## Husqvarna 40 - Husqvarna 50

### FLYWHEEL

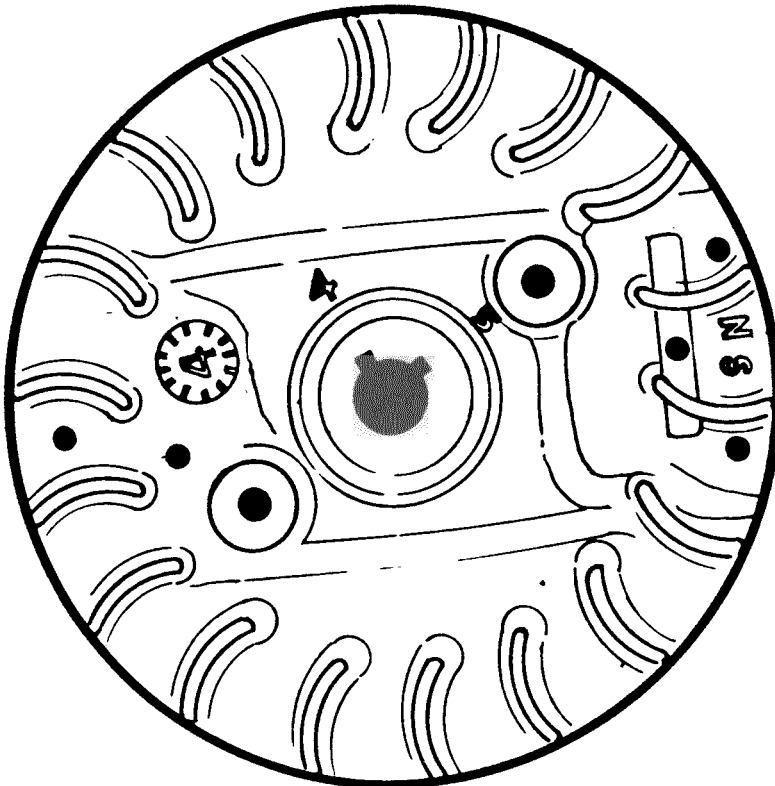
We have into our production introduced a flywheel with 2 keyways.

The keyways are marked 4 and 5 respectively.

For Husqvarna 40 keyway marked 4 is used.

For Husqvarna 50 keyway marked 5 is used.

Flywheel compl. Husqvarna 40                      506 03 13-04

Flywheel compl. Husqvarna 50                      506 03 13-01
